TO: Mercedes-Benz Dealer Principals, General Managers, Sales Managers, Service Managers, Parts Managers	FROM: Anthony Washington, Senior Manager, Regulations and Certifications
<b>Re: Launch Recall Campaign Notification</b> <b>Model: Metris (447)</b> <b>Model Years: 2022-2023</b> <b>Replace Fuel Delivery Module</b>	DATE: April, 2024

<b>Campaign No. :</b>	<b>Campaign Desc. :</b>	<b>Replace Fuel Delivery Module(dealer inventory only)</b>
<b>2024040005</b>	<b>VS2KRAPUM2</b>	
<p>This is to notify you of a Recall Campaign Launch to replace the fuel delivery module on approximately <b>80</b> MY 2022-2023 Mercedes-Benz Metris vans. The recall campaign will be visible on the <a href="http://www.safercar.gov">www.safercar.gov</a> website and may generate questions from customers. All affected VINs will be flagged "<b>OPEN</b>" in VMI and cannot be sold until the recall has been remedied.</p>		
<b>Background</b>		
<b>Issue</b>	<p>Mercedes-Benz AG, the manufacturer of Metris vans, has determined that on certain Metris (447 platform) vehicles, the fuel pump impeller might not meet specifications in regards to material characteristics. As a consequence, the impeller might deform and come into

S47.20-A027-03

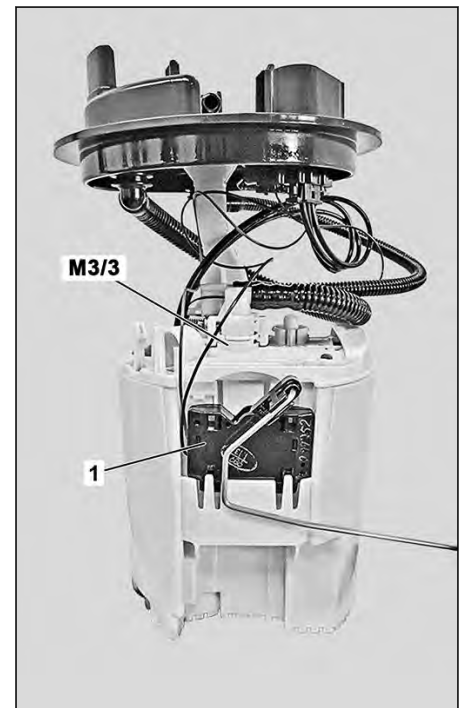
- 1      *Fuel tank fill level sensor*
- M3/3      *Fuel pump with fuel feed module*

<b>Modify</b>		
5	Transfer fuel tank fill level sensor (1) of removed fuel pump with fuel delivery module (M3/3) to new fuel pump with fuel delivery module (M3/3).	Only if new fuel pump with fuel delivery module (M3/3) was delivered without fuel tank fill level sensor (1).	AR47.50-S-0111E
